March 23, 2015

Re: Vienna Community Center (13319)
Additional Project Scope for Redesign of Gym

EXHIBIT SHOWING PARCEL ENCROACHMENT

GYM REVISION SKETCH

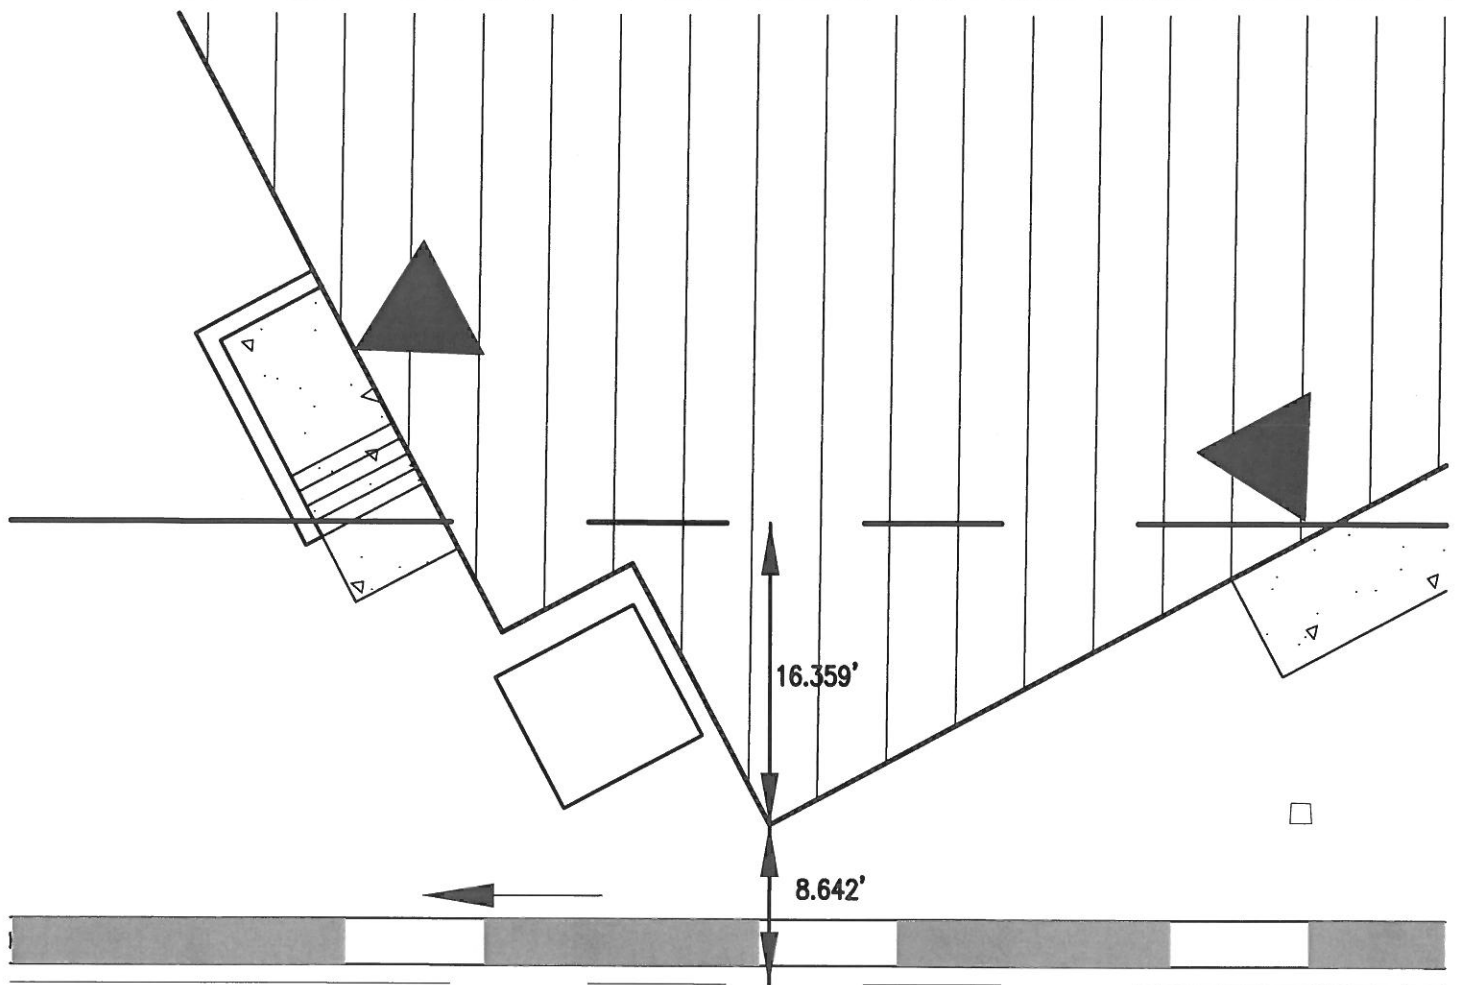
INDICATES REVISED FOOTPRINT
LOCATION WITHIN PROPERTY LINE

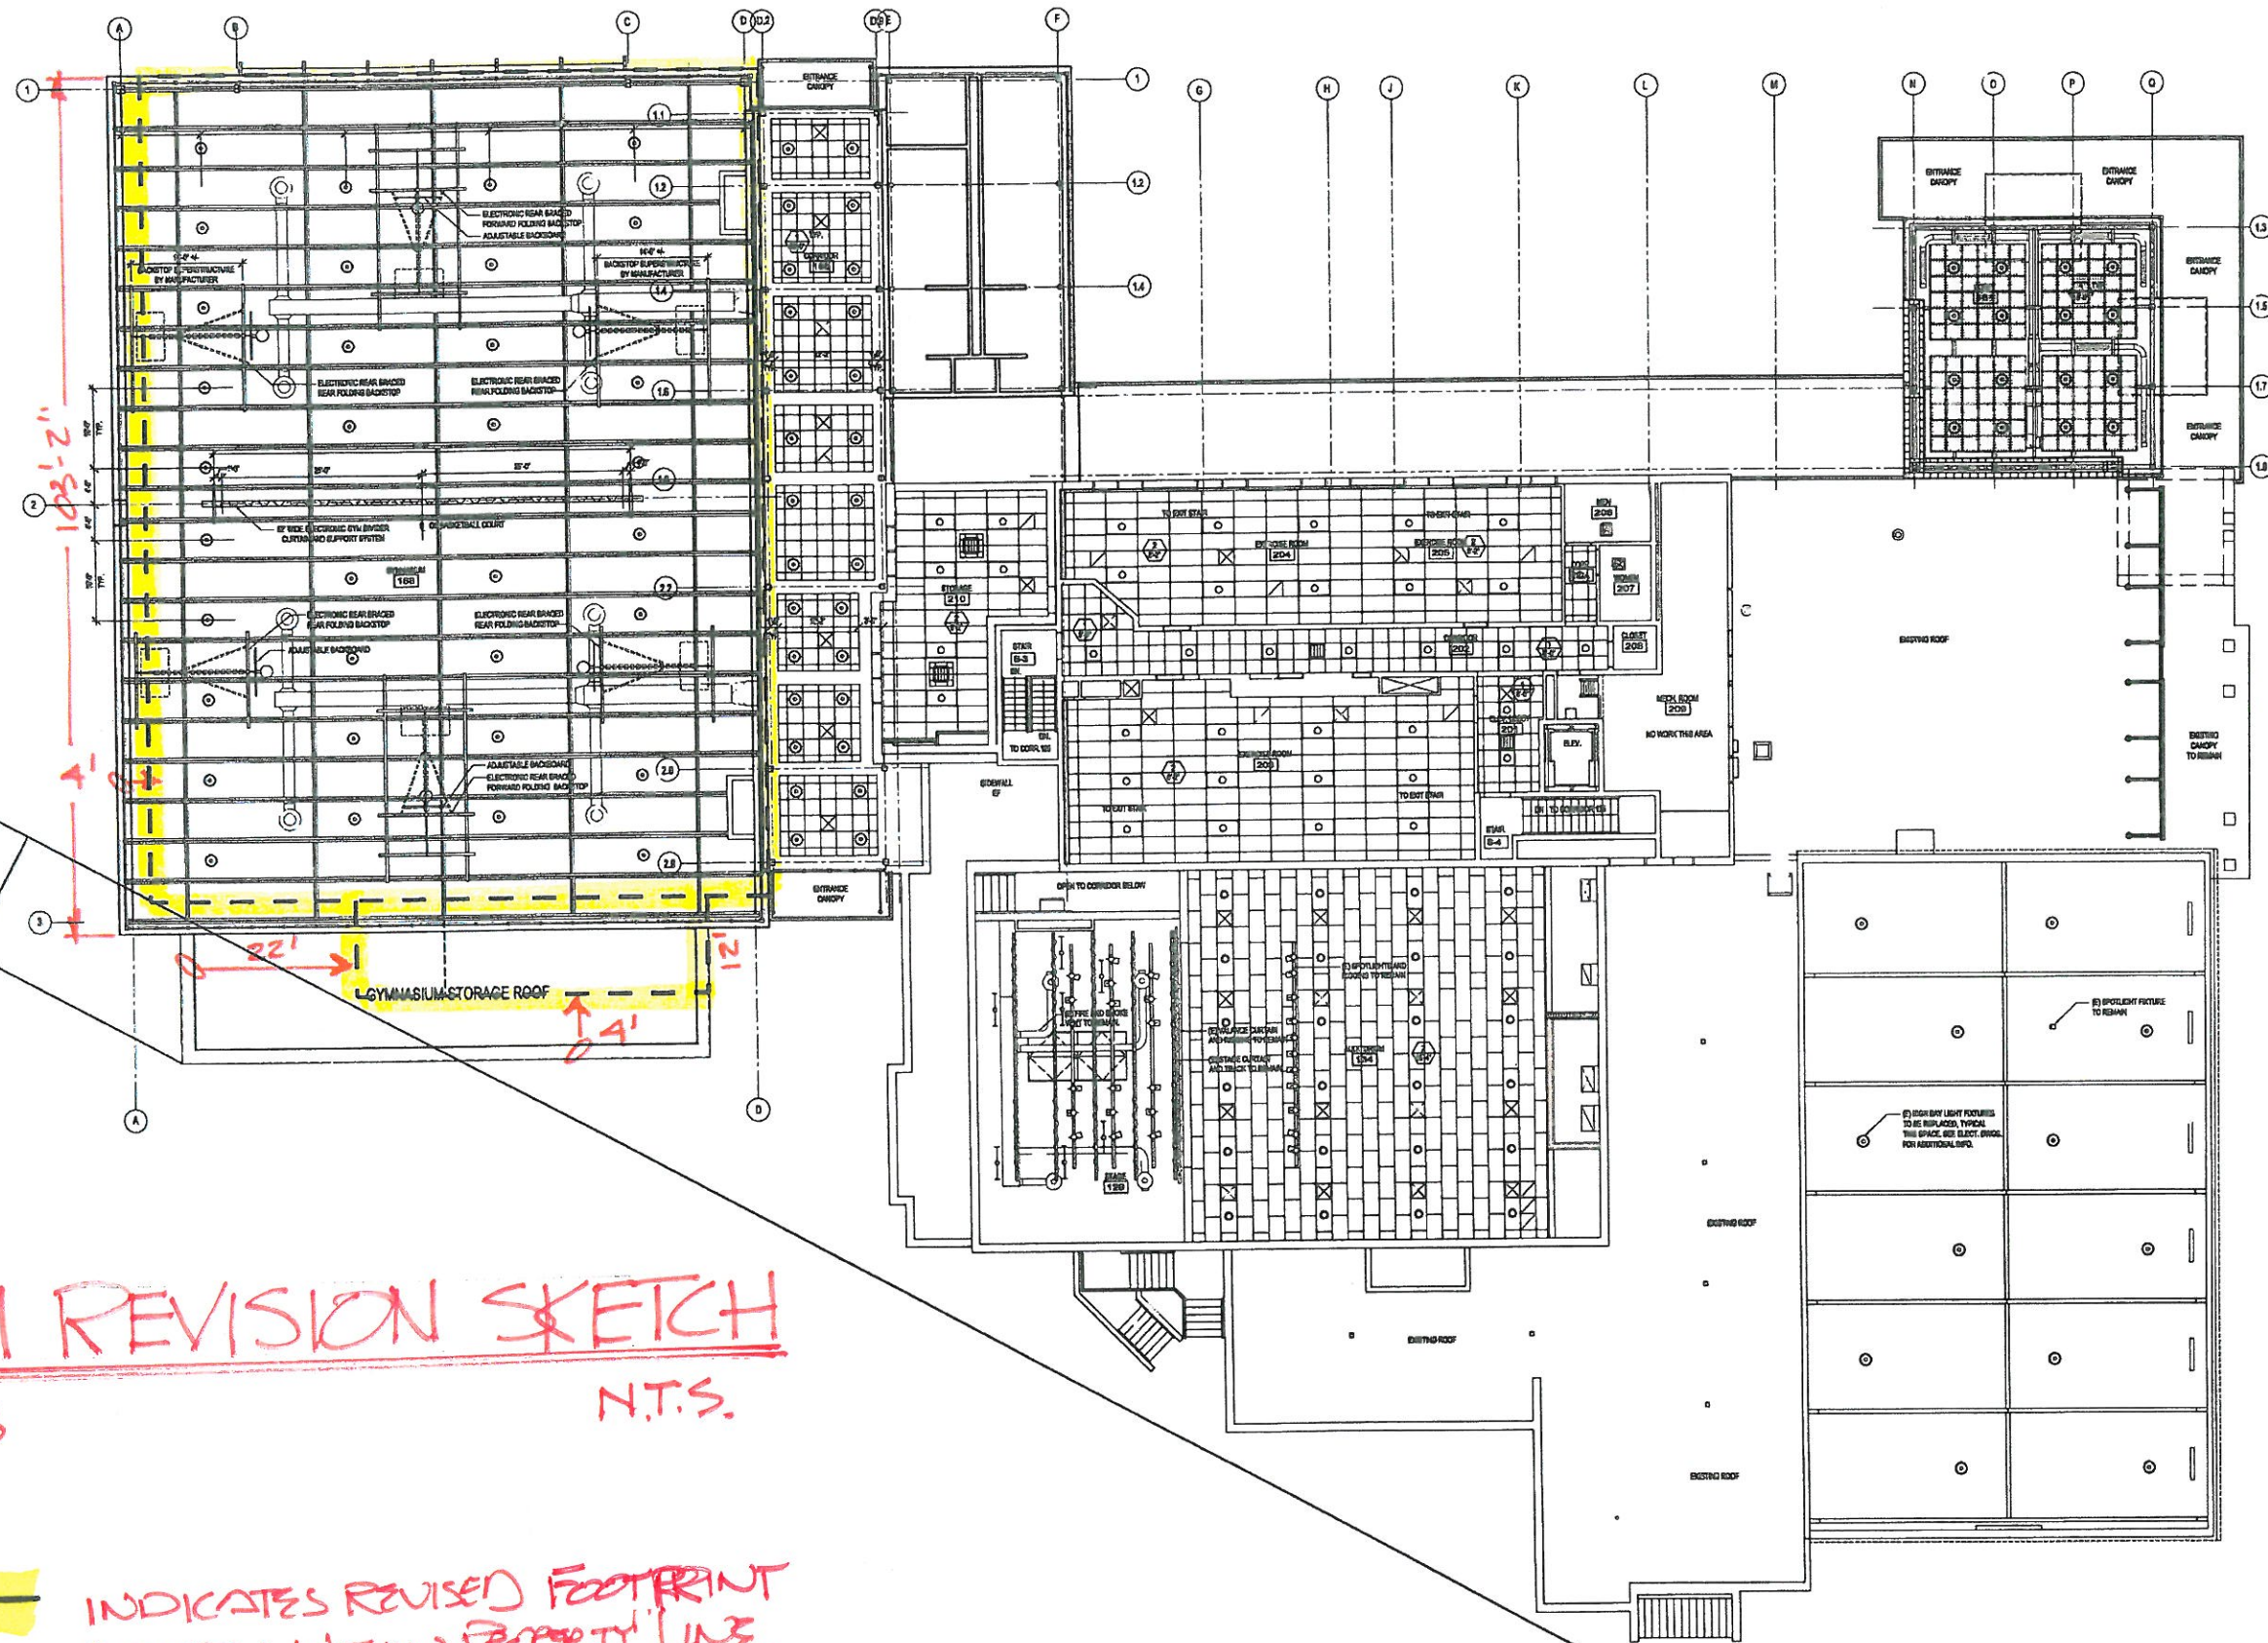
It has come to our attention that the easement property will not be available for use by this project and that the building footprint will need to be revised to lie entirely within the Vienna Community Center property boundaries. As per the ADTEK Exhibit submitted January 27, 2015, the SW corner of the new Gym Addition lies 16'-4" from the Vienna Community Center Boundary. A quick Option is attached that pulls the west wall of the Gym in 4' to the east and 4' to the north places the SW corner of the Gym just over the property line. The west wall of the Electrical Room/Storage block would also need to move 4' north and 22' east. The Electrical Room needs to remain here as it will receive the DVP primary power feed to the building and service the entire building. whatever is left can be used for storage. Options available include (1) a slightly reduced Gym Storage Room and no Theatre Storage, (2) slightly reduced Theatre Storage and no Gym Storage, or (3) greatly reduced Gym Storage and Theatre Storage. The Gym would lose one of the two jogging tracks provided. The courts would remain unchanged.
